LONDON BOROUGH OF
HARROW

Planning Committee Addendum

Date: Wednesday 19 July 2023

2/01 16 Montgomery Road, HA8 6NT – P/2882/23

P 2884/22

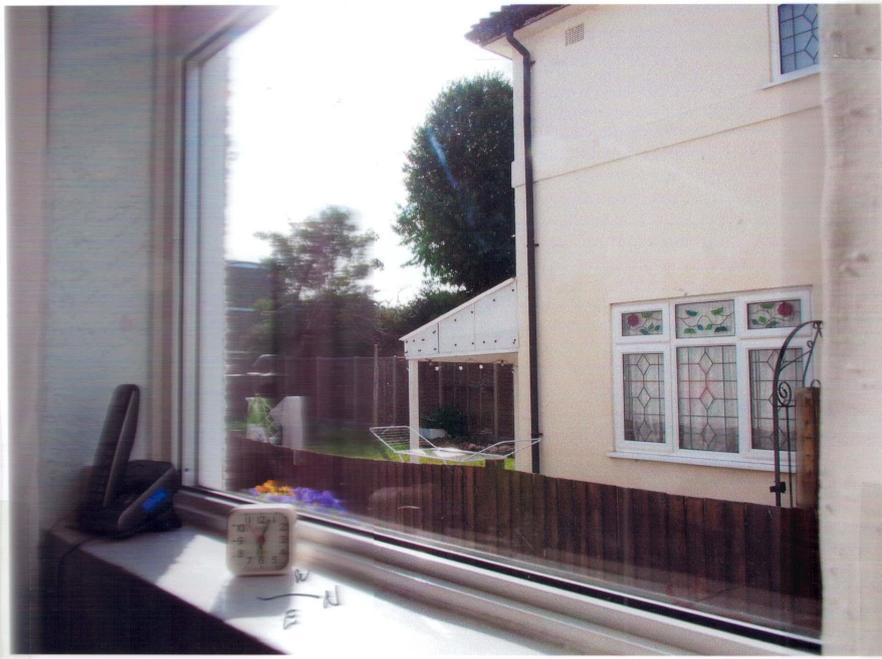
THIS SHOWS THE ACTUAL SUN THROUGH THE WEST WINDOW OF NO. 14. IT WAS TAKEN BETWEEN 6 AND 6.30 PM ON JULY 7TH - WHICH IS NOT FAR FROM THE SOLSTICE, SO THE SUN WILL LOWER AS THE MONTHS GO ON. IF YOU EXTEND THE TOP OF THE WALL OF NO. 16 ON THE PHOTO IT IS OBVIOUS THAT ANY EXTENSION OF THE UPPER STOREY WILL OBLITERATE ALL SUNLIGHT TO MY HABITABLE ROOMS AND CONSIDERABLY REDUCE THE LIGHT AS THE SKY WILL BE MOSTLY HIDDEN BY BUILDING.

AN EXTENSION OF THE GROUND STOREY ONLY WILL NOT AFFECT THE LIGHT.
